STAFF RECOMMENDATION
1714 5th Avenue North
August 15, 2018

Application: New Construction—Rear Addition and Outbuilding; Setback Determination
District: Salemtown Neighborhood Conservation Zoning Overlay
Council District: 19
Map and Parcel Number: 08205003600
Applicant: Lynn Taylor, Designer
Project Lead: Sean Alexander, sean.alexander@nashville.gov

SITE PLAN

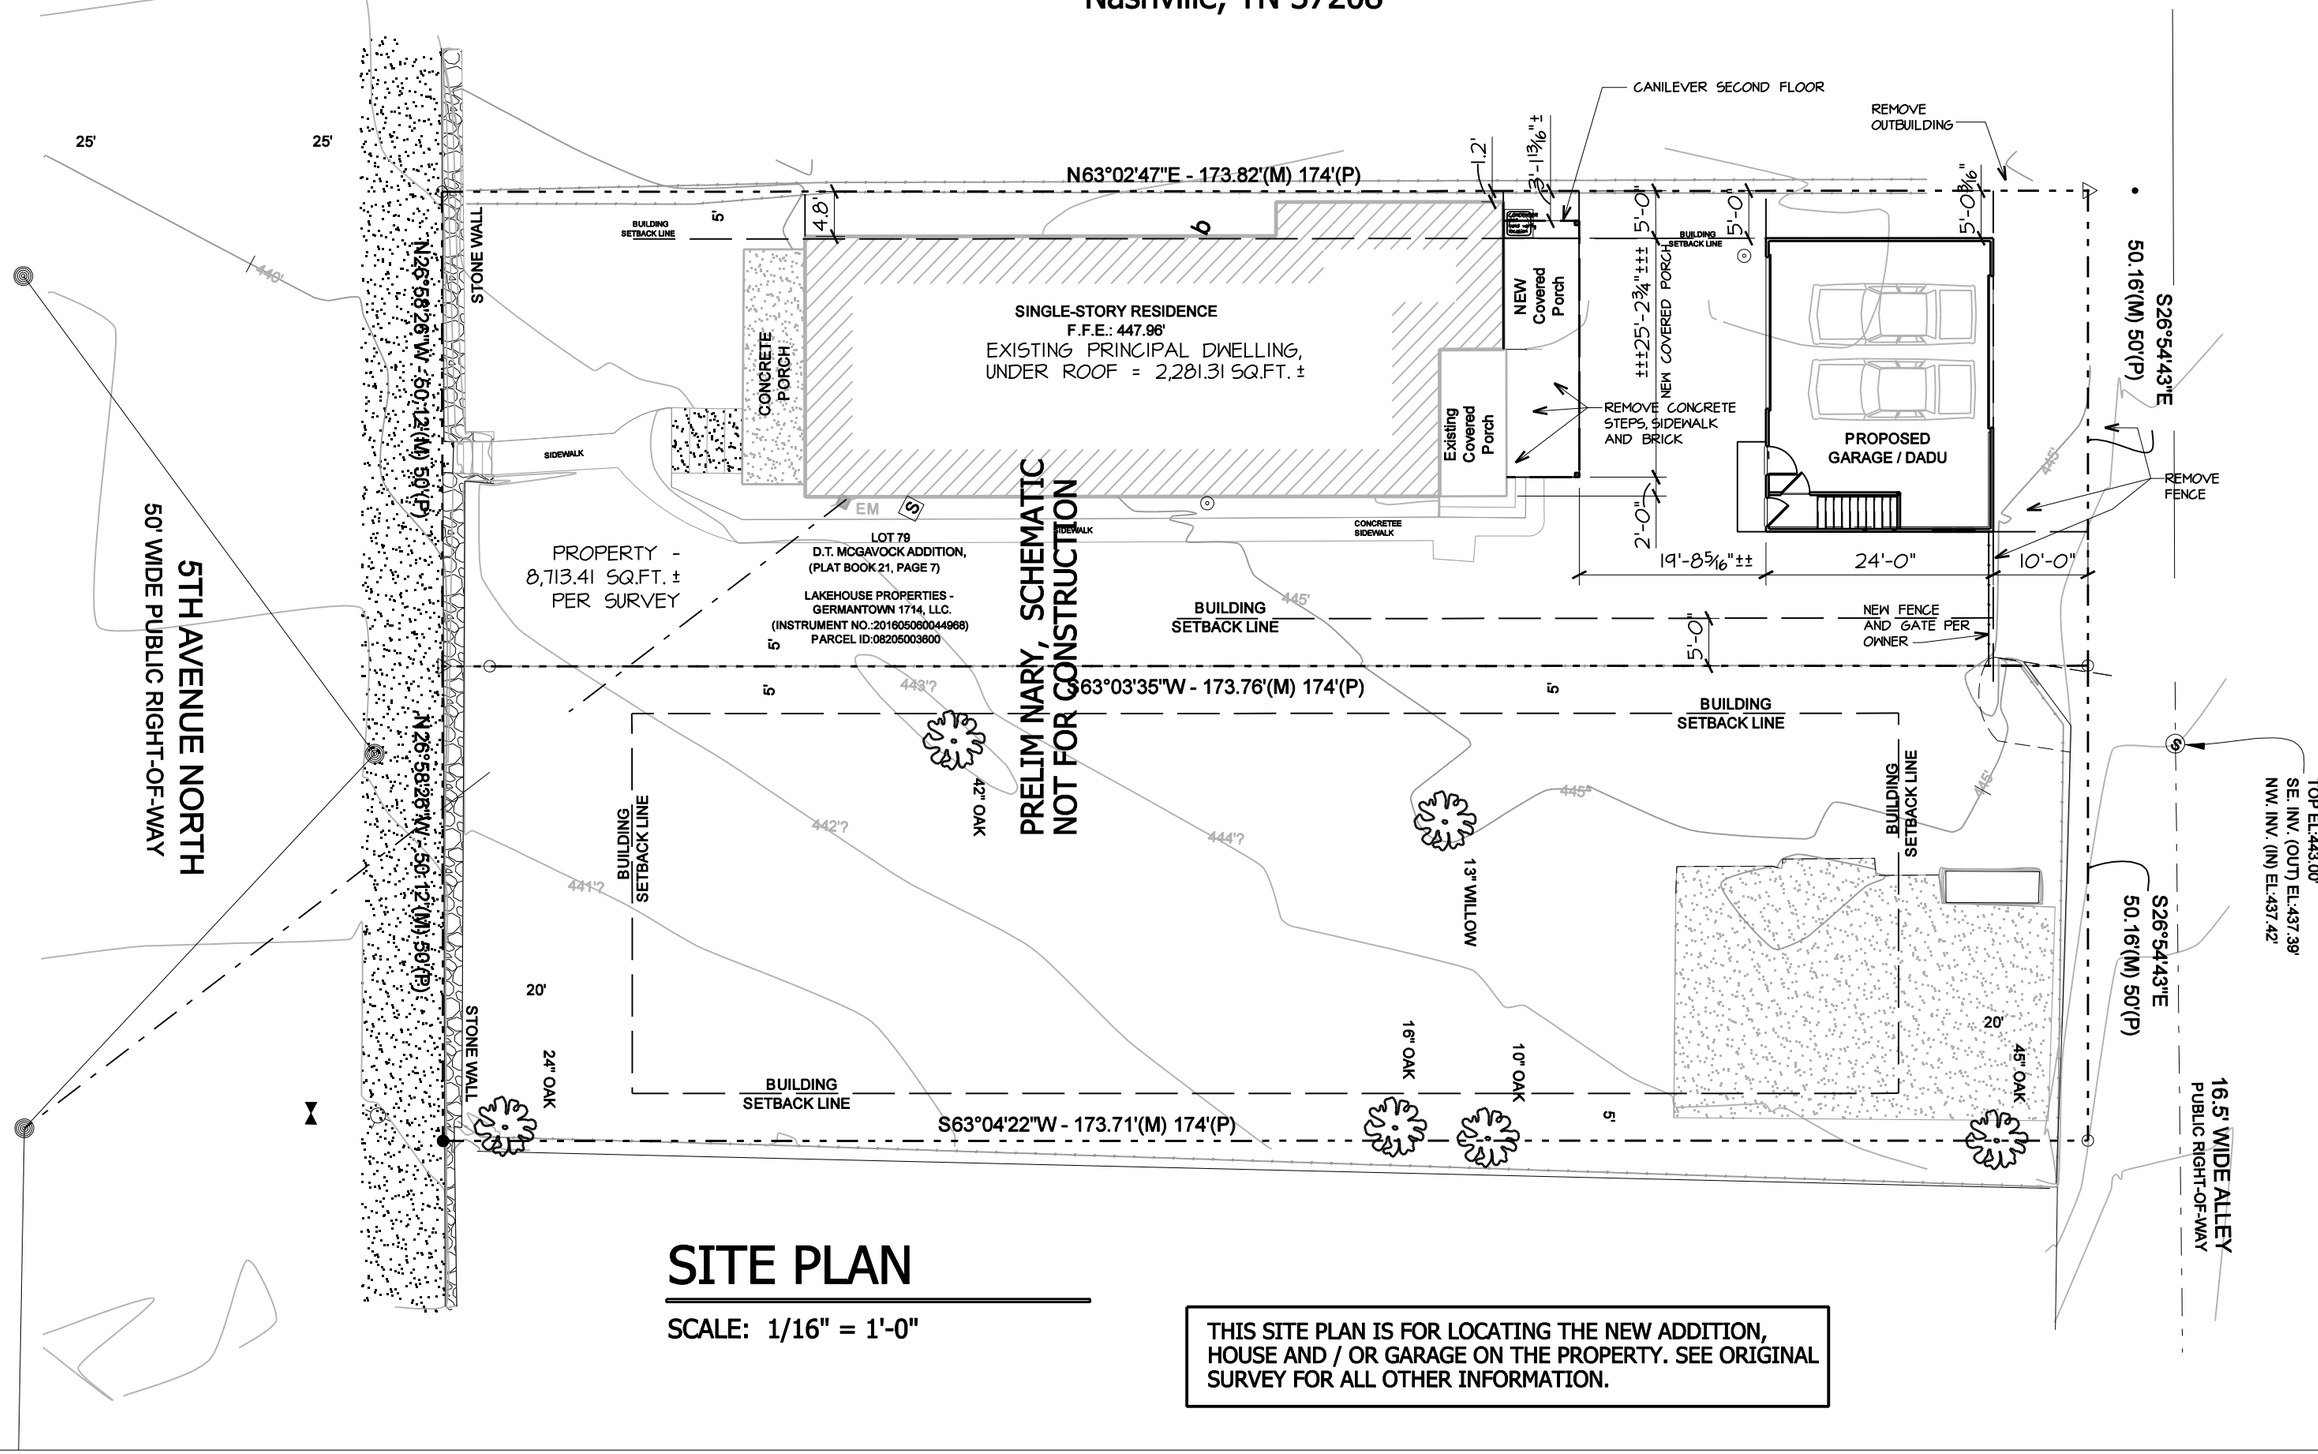
MINIMUM	PROPOSED
Space between principal building and DADU/Garage	20'	20'
Rear setback	5'	10'
L side setback**	5'	5'
R side setback**	5'	14'
How is the building accessed?	From the alley or existing curb cut	Alley

Staff finds that the location of the proposed outbuilding is compatible with the location of outbuildings historically and that it meets the setback and site planning requirements of section III.H of the design guidelines.

DEMOLITION
FIRST FLOOR PLAN

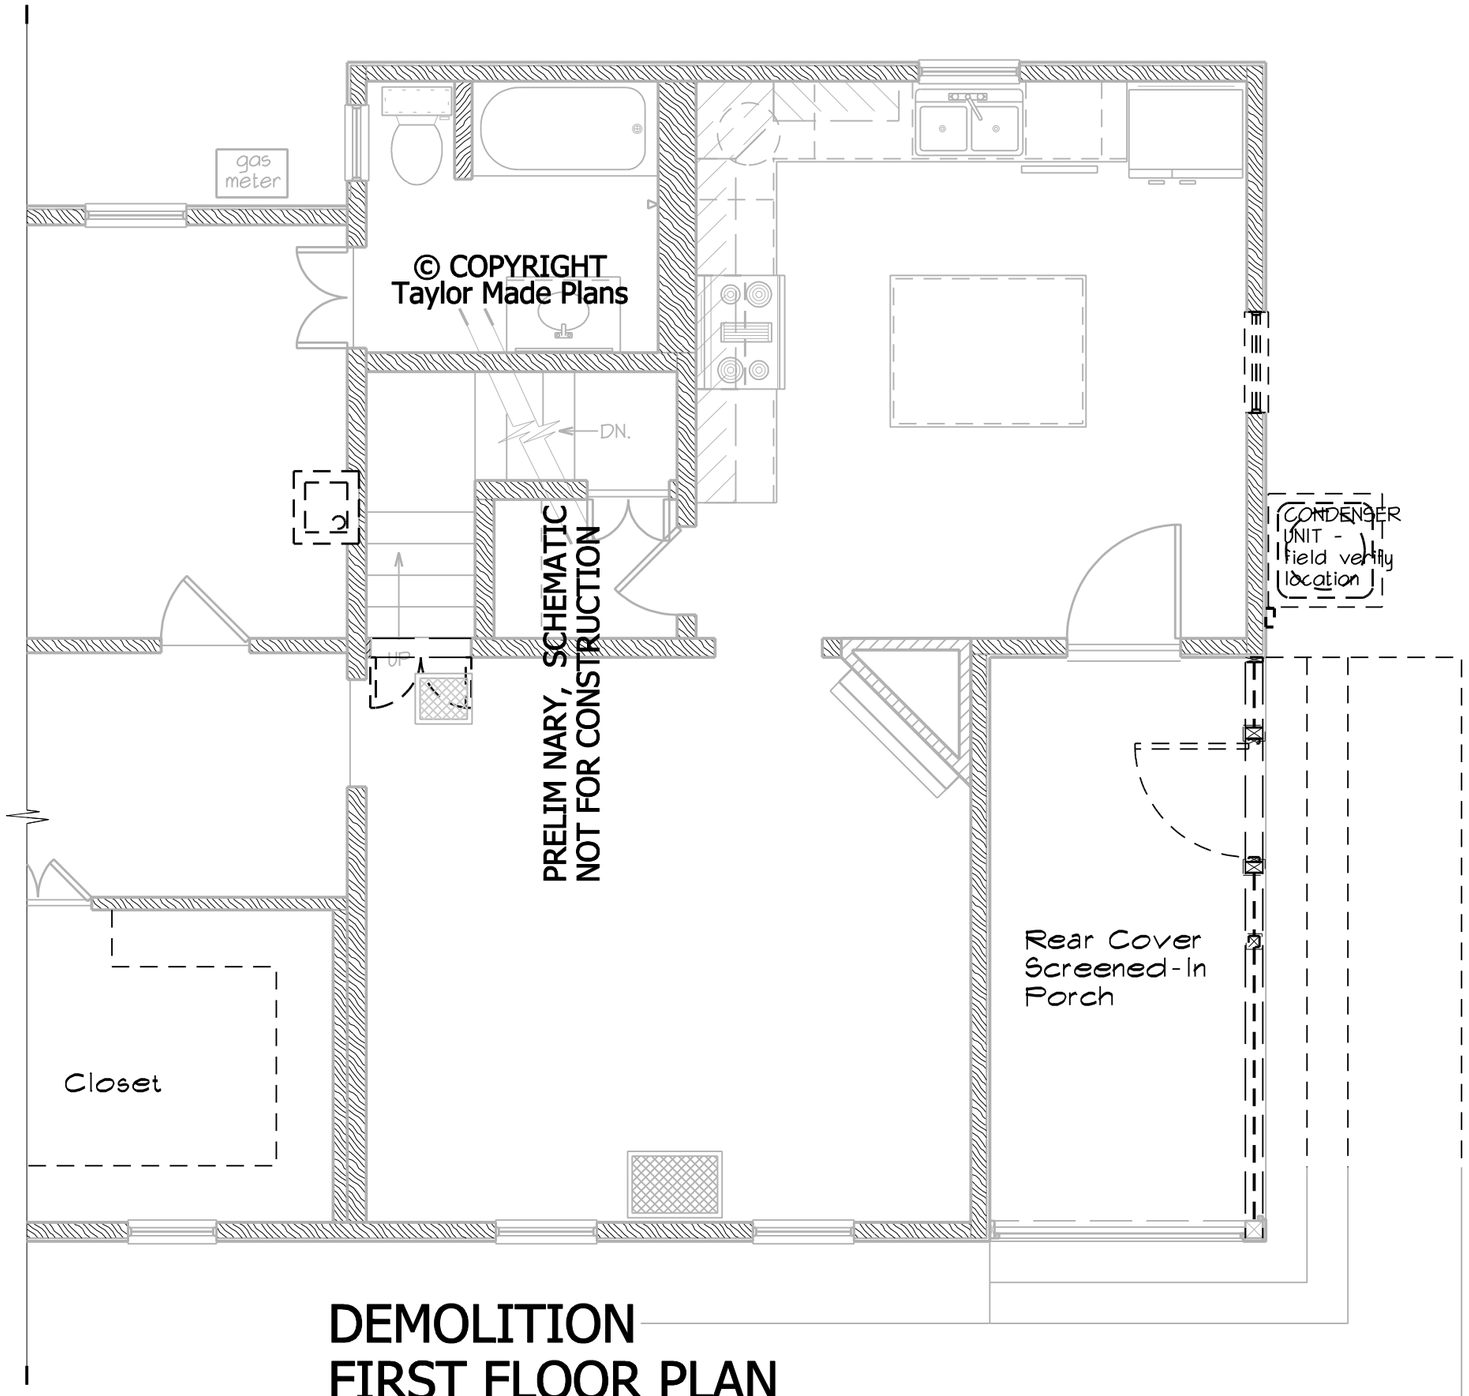
Demolition: A portion of the rear wall and rear roof slope will be demolished to accommodate the new addition. These sections of the building are only visible from the rear; therefore, the addition will not negatively affect the historic character of the house. Staff finds that the partial demolition meets Section V.B.2 for appropriate demolition and does not meet section V.B.1 for inappropriate demolition.

NEW CONSTRUCTION FIRST FLOOR PLAN

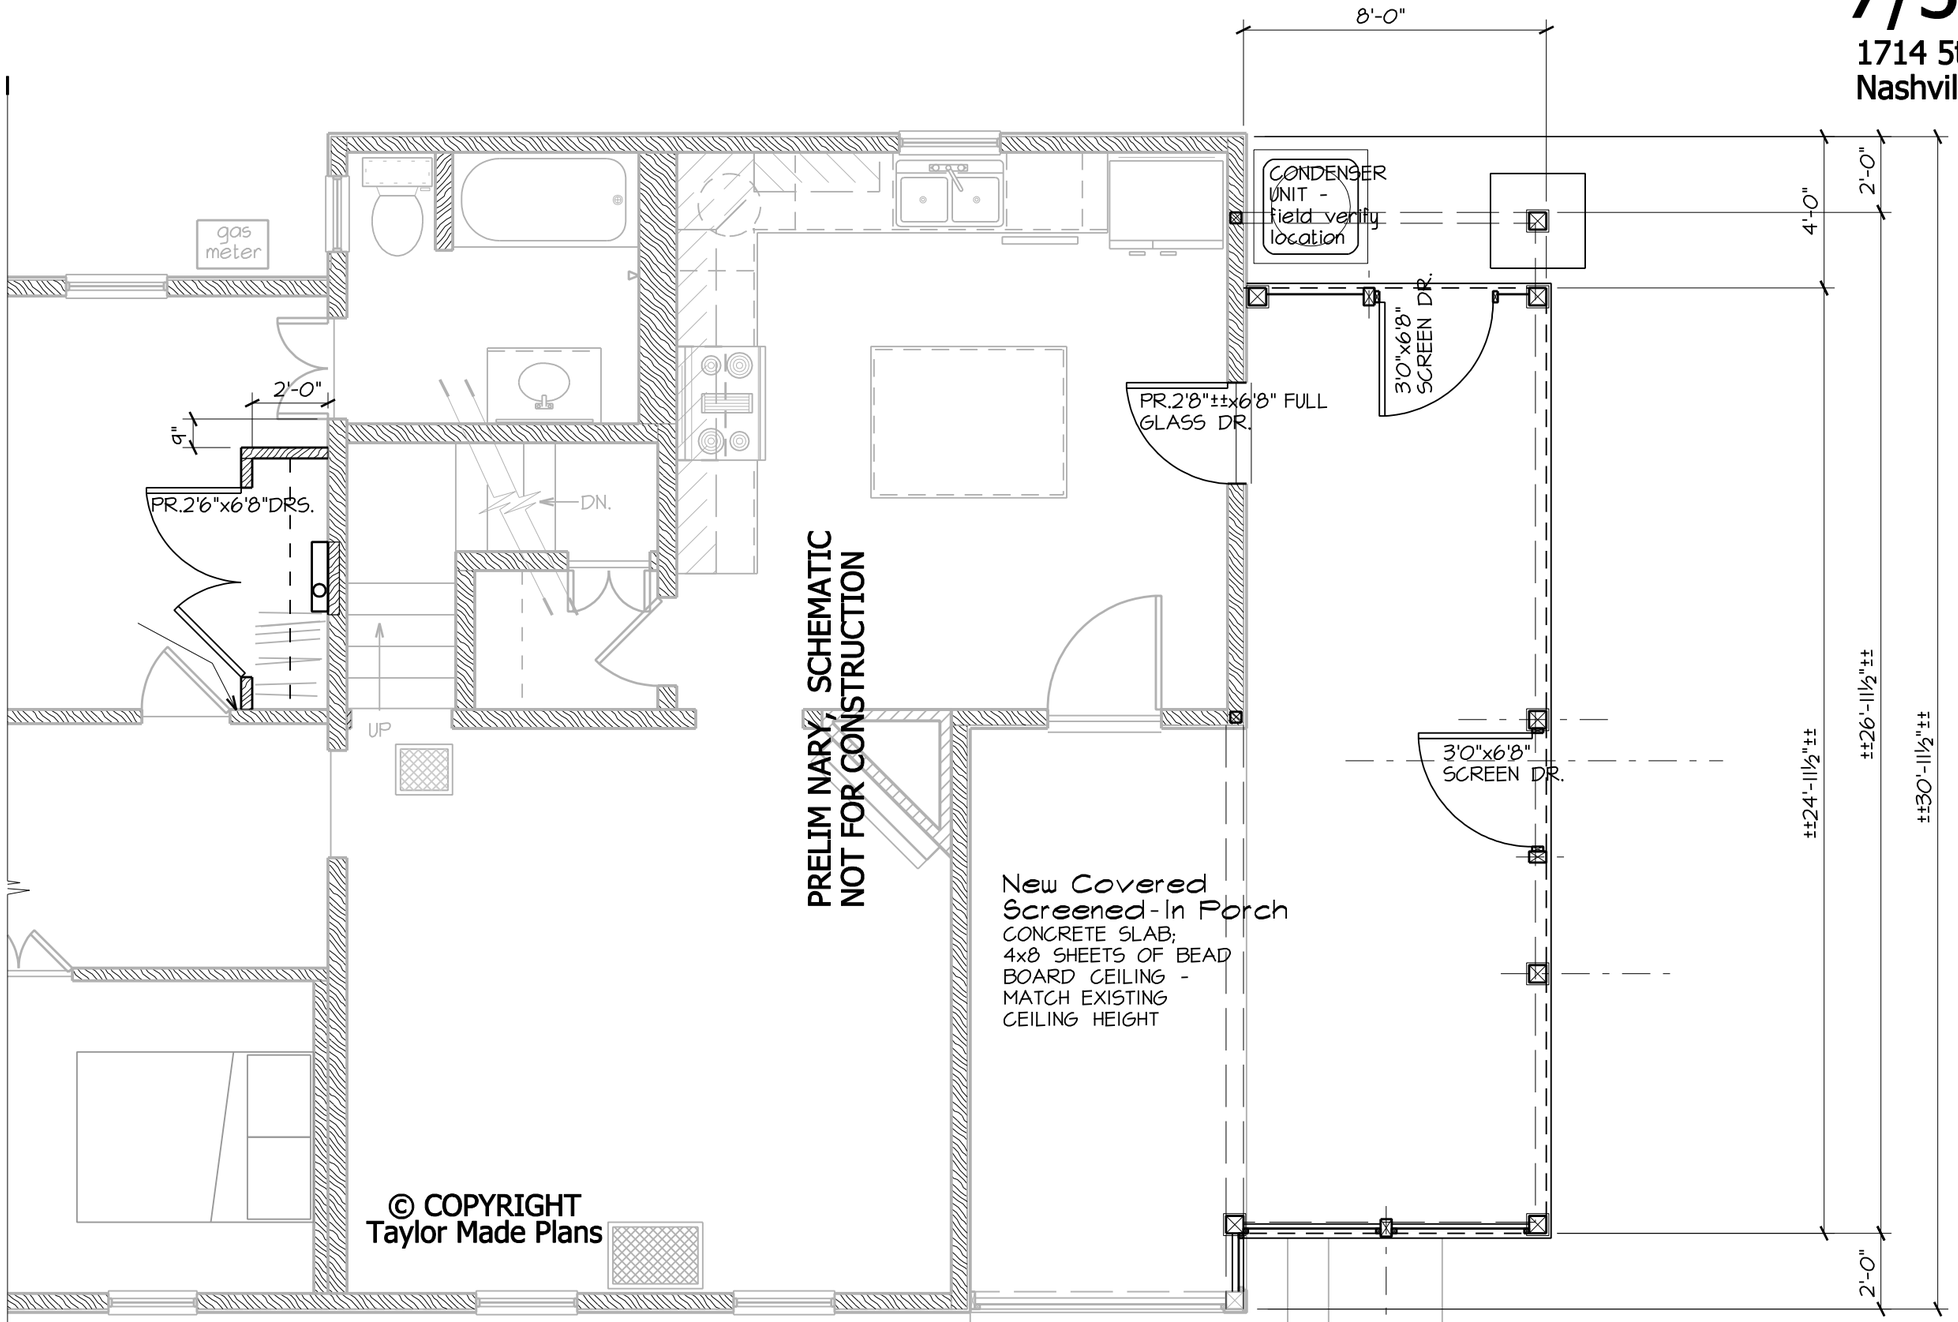
Setback & Rhythm of Spacing: Although the addition will be stepped in two feet (2') from the sides of the house, the new construction will sit within the standard five foot (5') setback because the left side of the building currently sits only one foot (1') from the left property line. Staff finds that the resulting three foot (3') side setback for the addition is appropriate because it is compatible with the existing historic condition. Staff finds that the project meets section III.C of the design guidelines.

Appurtenances & Utilities: The plans indicate that an existing rear yard walkway will be removed and that the HVAC units will be relocated. The new location of the HVAC was not noted, therefore Staff asks that they be located on the rear façade, or on a side façade beyond

the midpoint of the house. With that condition, Staff finds that the project meets section III.I of the design guidelines.
